Docket Item #8A-C

**James Bland Redevelopment Block "F"/ Phase 5
Master Plan Amendment #2011-0008
CDD Concept Plan Amendment #2011-0006
Development Special Use Permit #2011-0022**

Purpose of Application

A consideration of requests to amend Development Special Use Permit #2008-0013 (James Bland) to construct three multi-family buildings instead of one multi-family building on Block "F" and amend the Braddock East Master Plan and CDD Concept Plan to increase the height of the market rate multi-family building by 12 feet (48' to 60').

Attachment #2 – Open Space Expansion

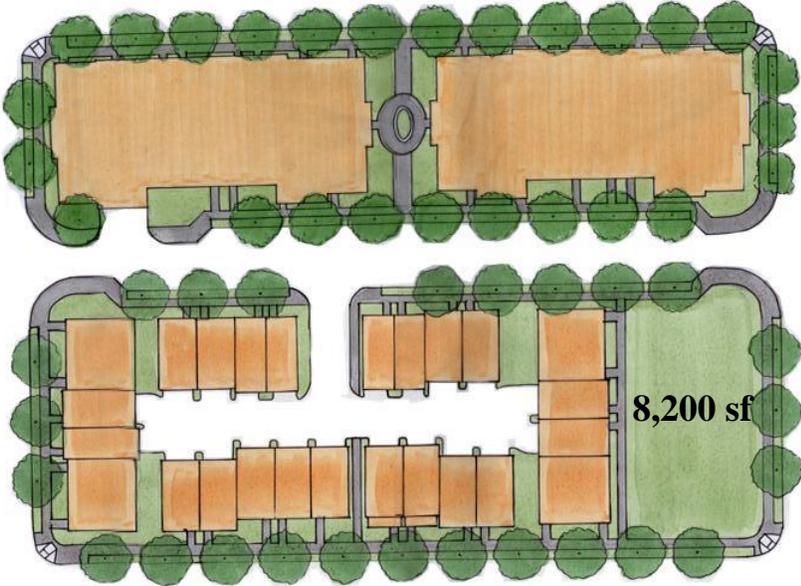
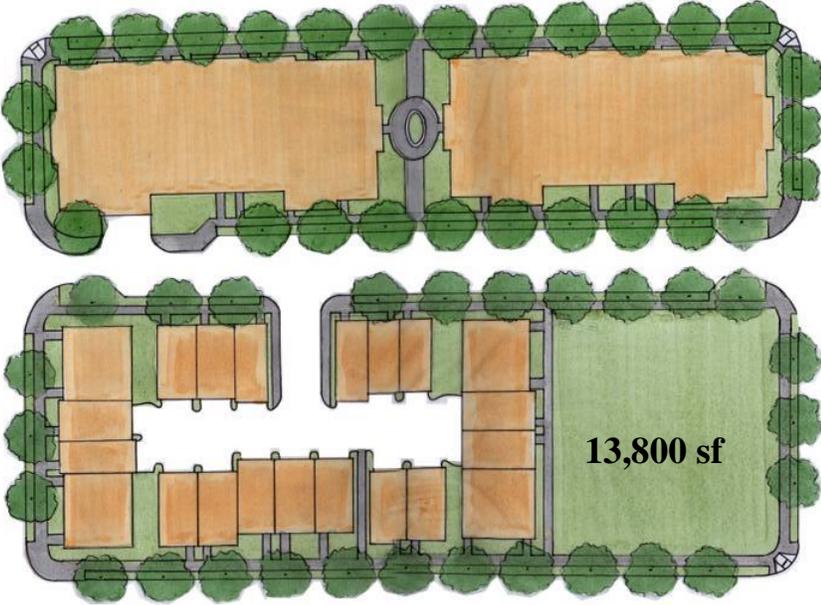
9. The applicant shall revise the site plan to eliminate 4 units in the southwestern block to provide a larger open space area at the corner of Montgomery Street and N. Alfred Street as generally depicted in *Attachment #2*. The park shall be subject to the following, to the satisfaction of the Directors of P&Z and RP&CA:

Attachment #5 - Braddock East Master Plan - Amended Pages

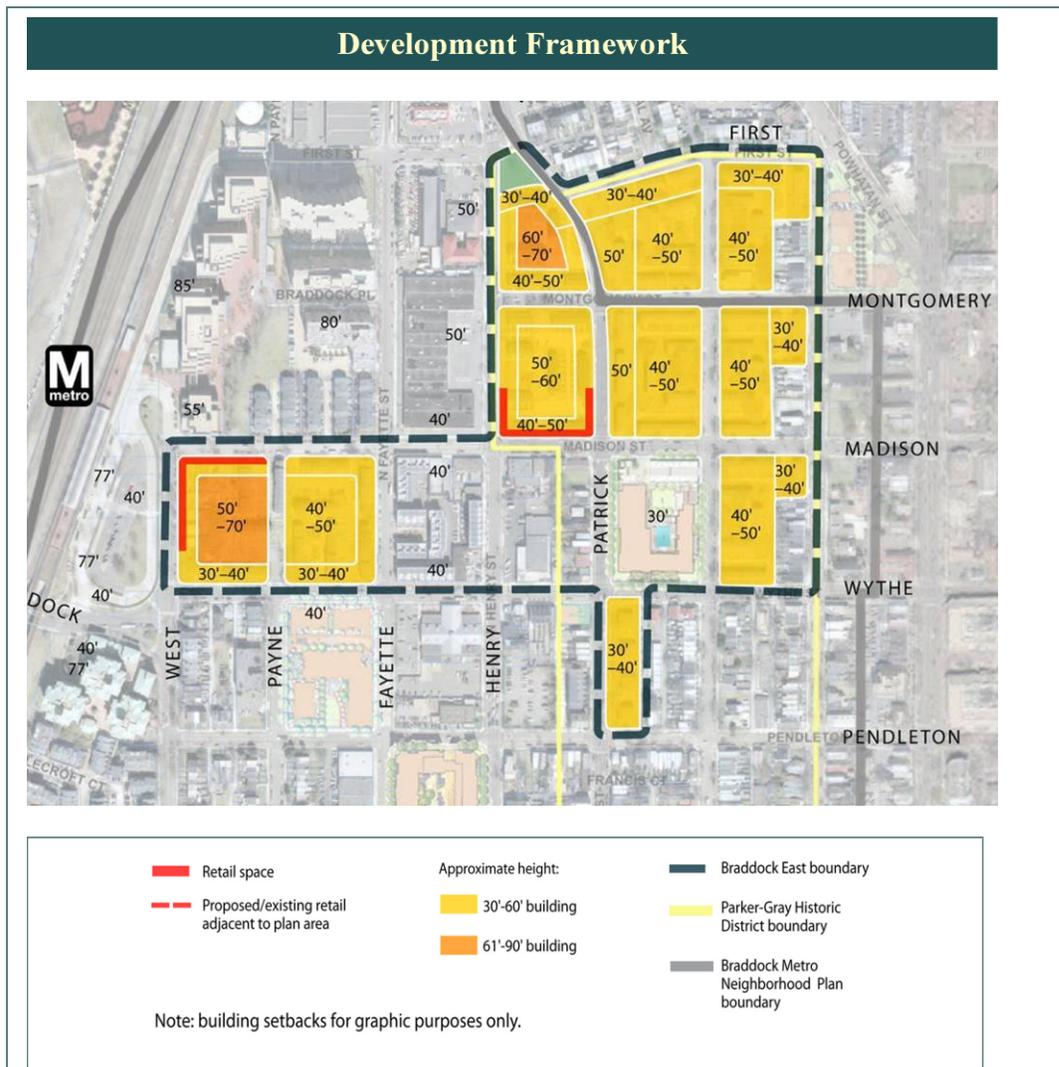
shown on the Development Framework map on pages 5 and 46 and associated table #5 on page 47 require a change from 50 feet to 60 feet. Additionally, two references to a 50 foot height designation along N. Patrick Street will need to be adjusted to reflect the height change to 60 feet.

Staff recommends adding a footnote to these two text references, as well as to the associated maps and table, to allow for the additional height of 10 feet for this one building (see *Attachment #5* for amended pages). No other changes to the Master Plan will be necessary. This 10 foot increase will allow the additional height needed for the proposed fifth floor of the market rate building. This change will only apply to the market rate building and not to the two ARHA buildings located to the north and south of this building. Thus, the required step down to 30 - 40 feet for the ARHA building abutting First Street and the 50-foot height limit for the ARHA building abutting Montgomery Street will not change.
